**For** DECISION**Subject/Title**Ottawa Public Library (OPL) – Library and Archives Canada (LAC) Joint Facility —  
555 Albert Street — 100% Developed Design**Purpose of the Submission**To obtain approval of the Board of Directors for the 100% Developed Design of the OPL-  
LAC — Joint Facility**Recommendations**

# Ottawa Public Library / Library & Archives Canada Joint Facility

NCC Report  
March 11, 2021

Excerpt of the Minutes

## **View from Albert Street:**

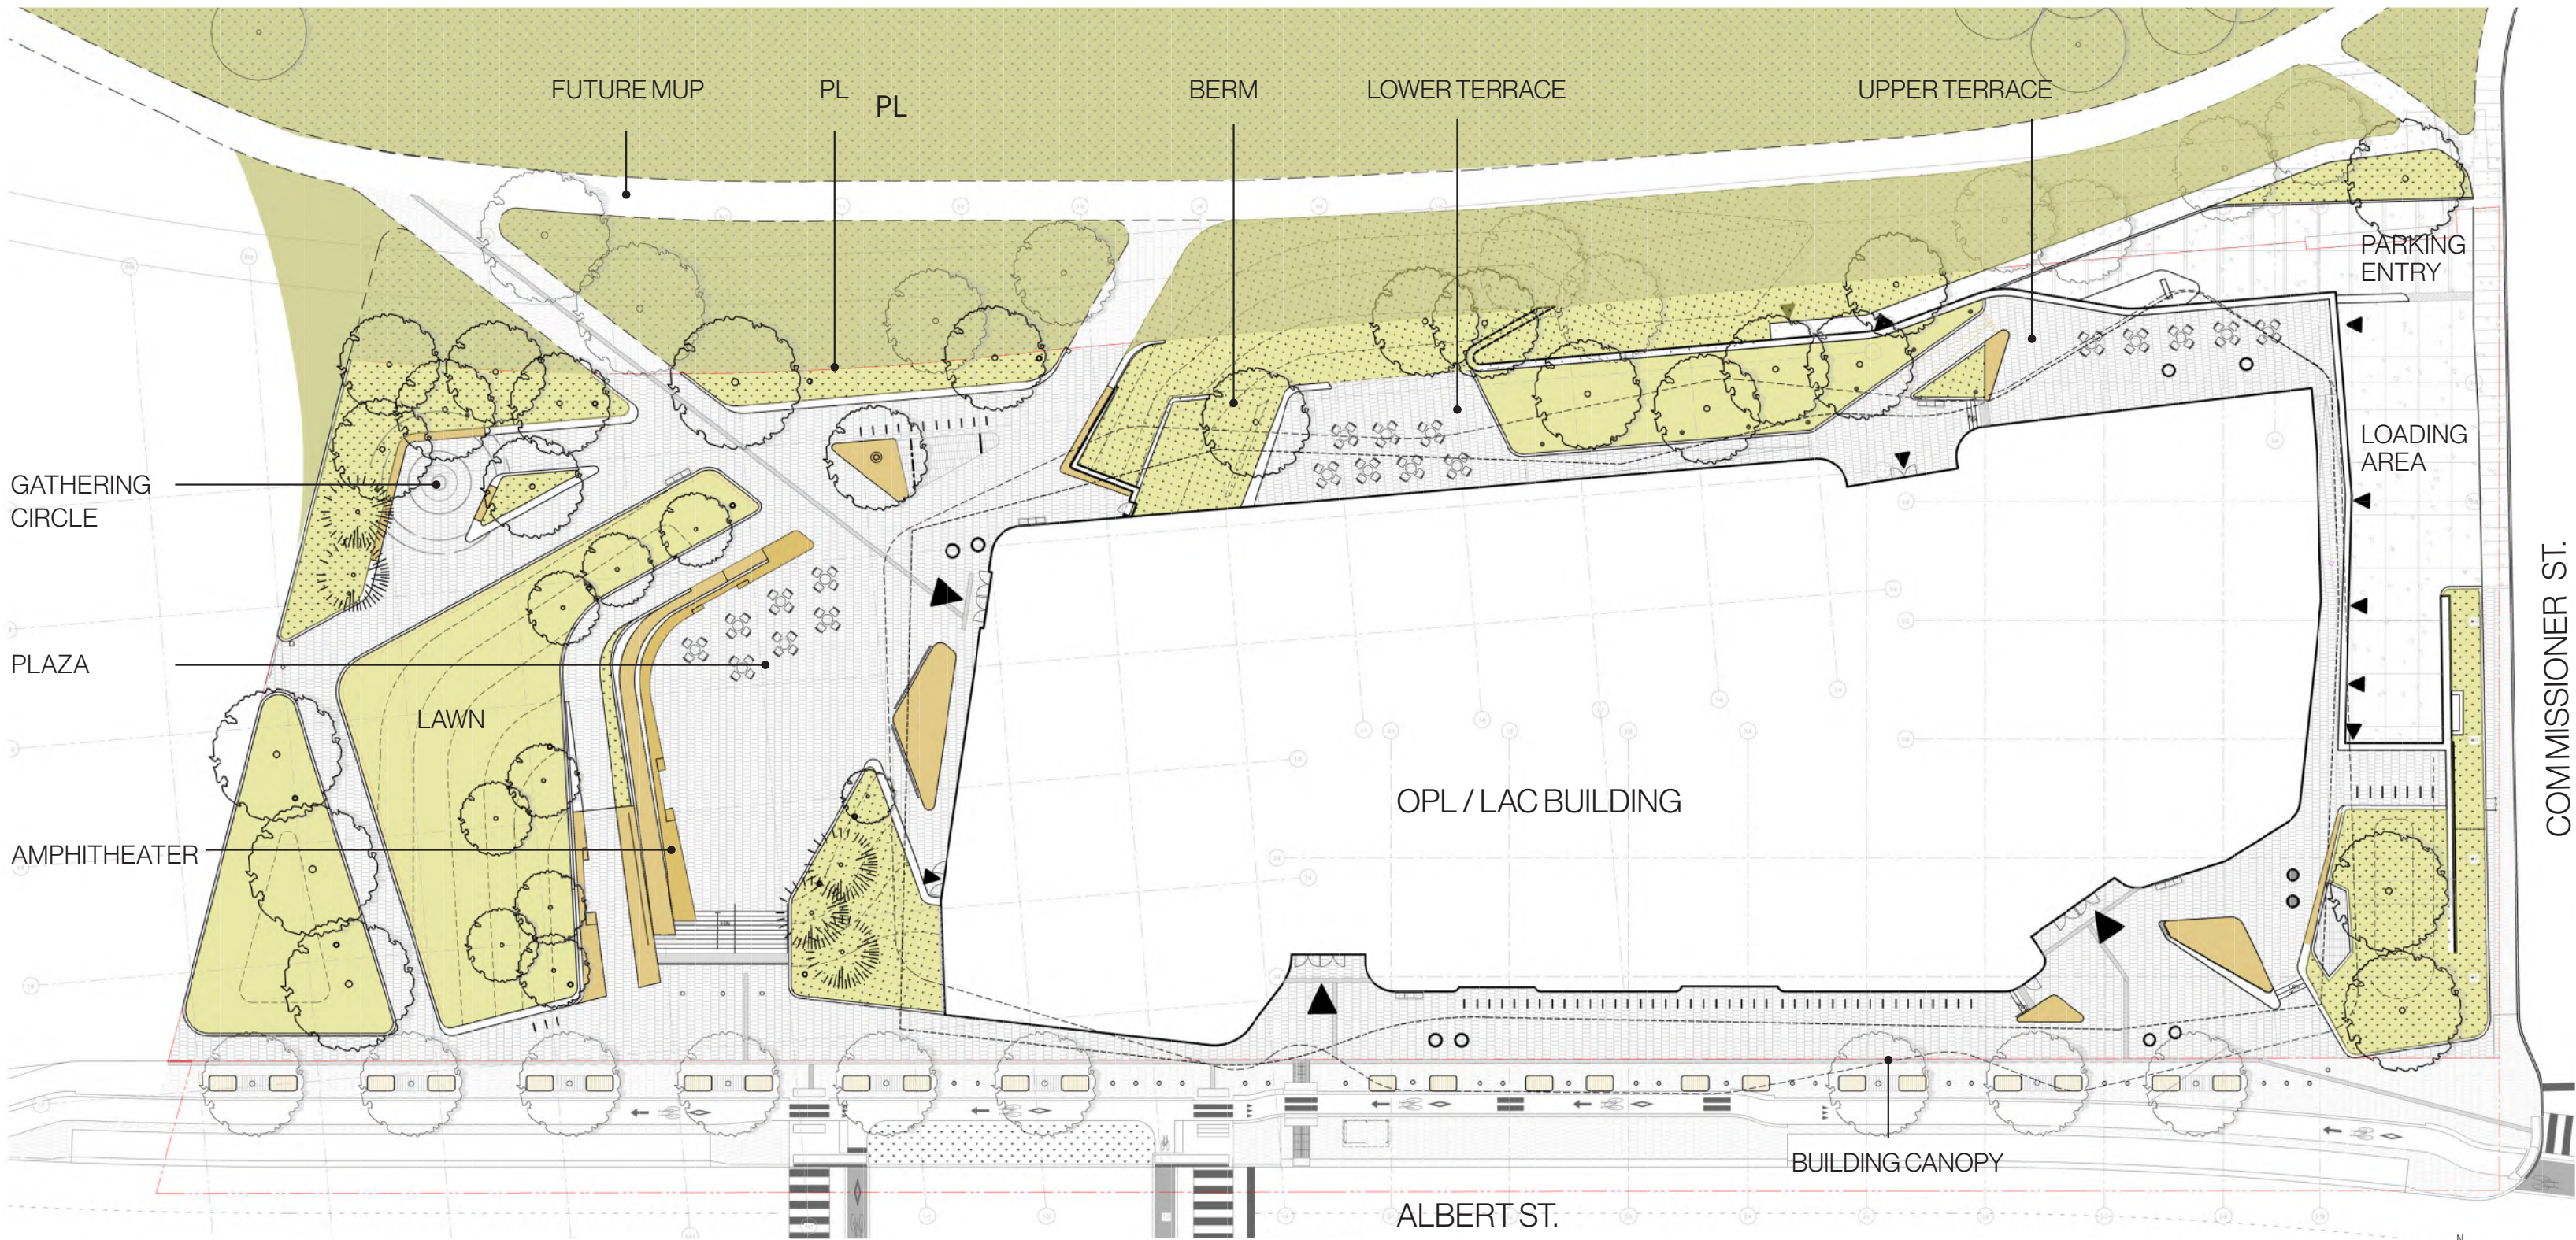
The westerly direction of traffic on Albert Street and the position of the OPL-LAC Joint Facility on the escarpment edge as Albert Street transitions from the downtown zone to the emerging LaBreton Flats district provides the opportunity for the building to function as a gateway.

The glazing at the upper storey of the building will serve as a beacon during the day and evening for the building face that is presented to Albert Street and the neighbourhood of the downtown to the east.

Several adjustments have been made to the design to take advantage of this prospect for the building, including a shallow vaulting (curving) of the roofline of the east façade, and a shallow vaulting of the mechanical penthouse elements to repeat the vaulted shape of the eave roofline.

The refined roof silhouette will participate with the glowing light of the upper floor glazing to reinforce the 'beacon' character of the architecture that addresses the downtown area and Albert Street east.
